UNITED STATES PATENT AND TRADEMARK OFFICE

APPLICATION NO.	FILING DATE	FIRST NAMED INVENTOR	ATTORNEY DOCKET NO.	CONFIRMATION NO.
10/644,720	08/20/2003	Jeffrey C. Hessenberger	066042-9398-01	6121

Office Action Summary	Application No.		Applicant(s)	
	10/644,720		HESSENBERGER ET AL.	
	Examiner		Art Unit	
	Shelley Self		3725

DETAILED ACTION

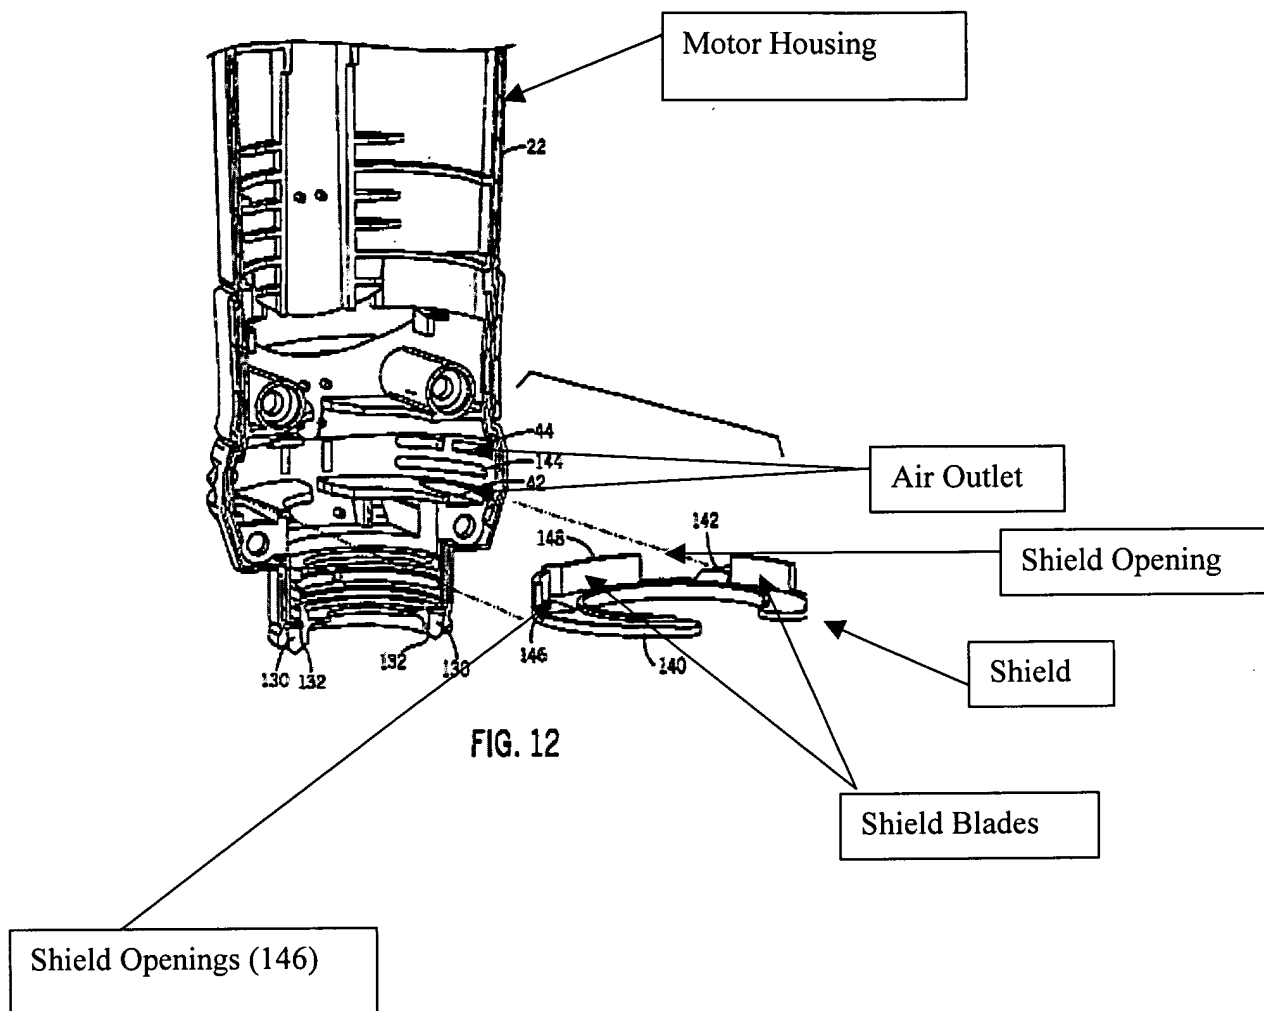
Further Kopras discloses the shield connectable to the motor housing, the shield being positionable at least partially outside the motor housing (fig. 1). Examiner notes the shield to have a tab (142) which protrudes outside the motor housing (22) so as to rotate the shield within the motor housing (22) to at least partially cover portions of the air outlet (42, 44).

As to the recitation, "*removably connectable*" (clm. 1) Examiner notes the shield (140) is not fixed within the housing (22) as clear by the movement of the shield to open/close the air outlets (42, 44) and shield (140) able to be removed from the housing because it is not fixed by any structure within the housing, i.e. pins, nail, fastener, clamp, screw, etc...

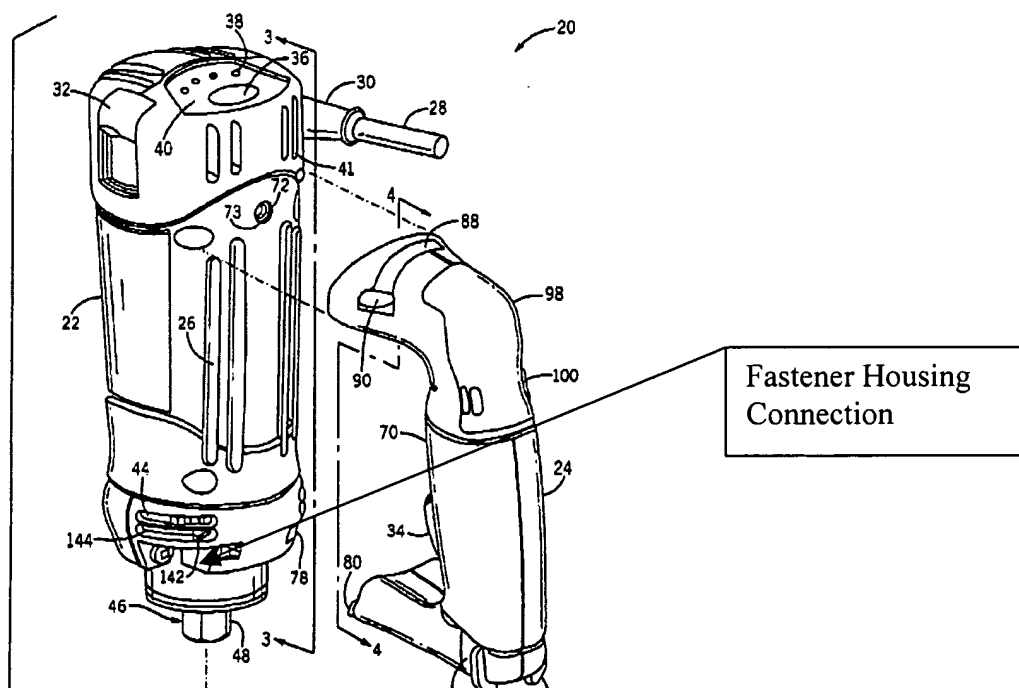
As noted in the previous Office Action, The prior art of record, Kopras discloses a power tool/router (fig. 1) comprising a base (56) for adjusting the depth of a rotary cutting tool (20), a motor (col. 8, lines 26-27) enclosed in a motor housing (22), a motor shaft attached to the motor and a cutting bit (col. 10, line 32), a removable shield (140) mounted in the motor housing (22; col. 6, lines 32-35) to open and close air outlets (42, 44) of the motor housing (22), wherein a portion of the shield (140) is positioned partially outside(fig. 1) the motor housing so as to rotate the shield to at least partially cover the air outlet (42, 44). Kopras does not disclose *wherein the motor housing includes a plurality of housing blades spaced apart from one another to define openings therebetween*. Kopras is silent to a plurality of housing blades defining openings therebetween. Instead Kopras discloses a shield (140) that acts to direct/channel and exhaust air via openings (146) and vertical blades (148) such that the shield is rotatable to open or close the housing air openings (42, 44). Additionally, Kopras does not disclose *a flexible shield connectable to the base in a position to cover the open end and to allow access to the depth adjustment mechanism through the open end*. Kopras is silent to any flexible shield. Kopras also fails to disclose or suggest *a plurality of radially extending shield blades*. Instead Kopras discloses shield blades (148) extending around or about the circumference (fig. 12) of the circular shield (140). To rearrange, Kopras such that the blades (148) extend about the radius of

the shield (140) would inhibit operation of Kopras, thus there is no motivation within the reference to rearrange the shield blades to a radial construction.

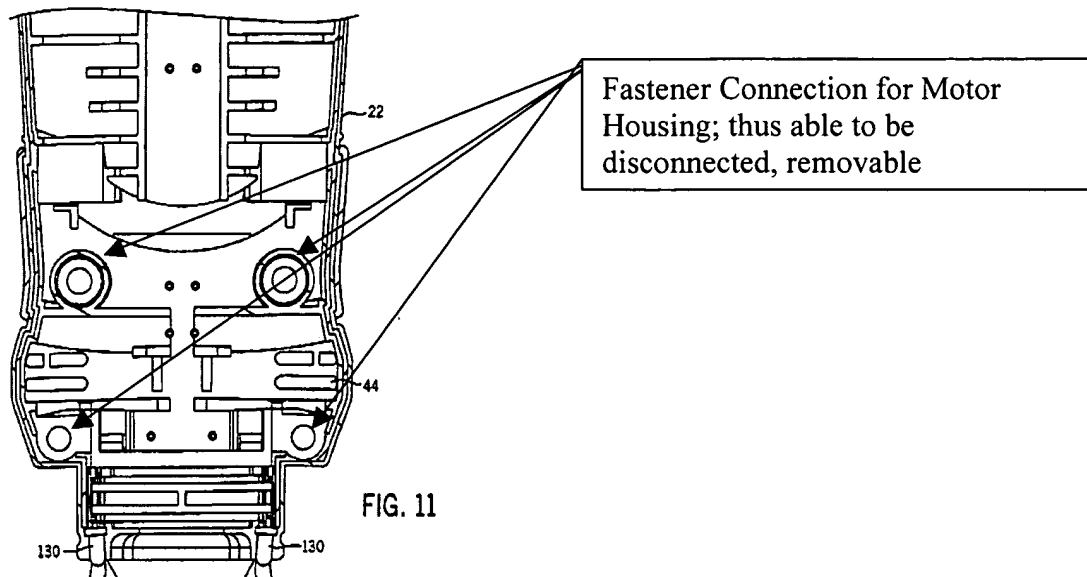
Kopras does not disclose or fairly suggest *the shield being operable to inhibit movement of debris through the air outlet and into the motor housing when the router is in the inverted position*. Although Kopras' construction is such that the shield is above the air outlet (42) when the router is in an upright orientation and below the air outlet (42) when the router is in an inverted position, Kopras does not disclose *the shield being operable to inhibit movement of debris through the air outlet and into the motor housing when the router is in the inverted position*. Instead in an inverted orientation, Kopras shield would not inhibit movement of debris through the air outlet and into the motor housing and would actually allow debris to fall due to gravity to the motor housing via the ring opening of the shield (140). Accordingly, Kopras teaches away from the claimed invention as set forth in claims 21 and 56.
